Access Compliance Report

Public Rights-of-Way

(Curb Ramps)

Intersection ID: 2544	Main Street: HARTFIELD_DOWNS_DR	Cross Street: HIGHLAND_CREEK_PY	Location: SW
ADA ID: C5A2465BEA79	Ramp Type: Perp	Initial Pass/Fail: Fail	Overall Compliance: No
Severity Score: 33.75			
Codes/Mitigation Info/Possible Solution		Field Measurements/Component Compliance

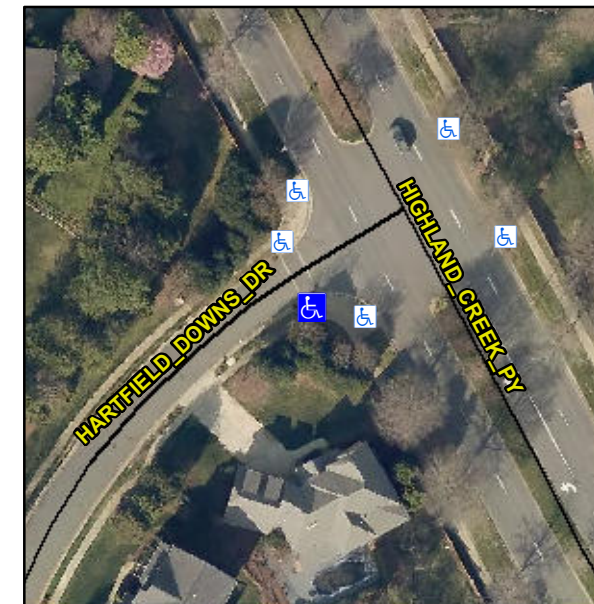
R304.5.1, R304.2.2, R304.5.3

Compliance	Description	Data	Compliance	Description	Data
N/A	Ramp Length (in)	65.0	No	Ramp Slope (%)	8.8
No	Ramp Width (in)	38.0	No	Ramp XSlope (%)	5.1
N/A	Flare Type LT	N/A	N/A	Flare Type RT	N/A
N/A	Flare Slope LT (%)	N/A	N/A	Flare Slope RT (%)	N/A
N/A	Flare Traversable LT?	N/A	N/A	Flare Traversable RT?	N/A
N/A	Landing Length (in)	N/A	N/A	DWS Provided?	N/A
N/A	Landing Width (in)	N/A	N/A	DWS Contrast?	N/A
N/A	Landing Slope (%)	N/A	N/A	DWS Length (in)	N/A
N/A	Landing X Slope (%)	N/A	N/A	DWS Full Width?	N/A
N/A	Landing Curb? (Y/N)	N/A	N/A	DWS Offset (in)	N/A
N/A	Shared Landing?	N/A			
N/A	Gutter Ponding?	N/A	N/A	Gutter Slope (%)	N/A
N/A	Gutter Lip Ht (in)	N/A	N/A	Gutter X Slope (%)	N/A
N/A	Painted X Walk1?	Yes	N/A	Painted X Walk2?	N/A
	X Walk 1 Direction	To N		X Walk 2 Direction	N/A
N/A	X Walk 1 Width (in)	96.0	N/A	X Walk 2 Width (in)	N/A
	X Walk 1 Slope (%)	3.0		X Walk 2 Slope (%)	N/A
	X Walk 1 X Slope (%)	4.0		X Walk 2 X Slope (%)	N/A

Remove & Replace Entire Ramp.
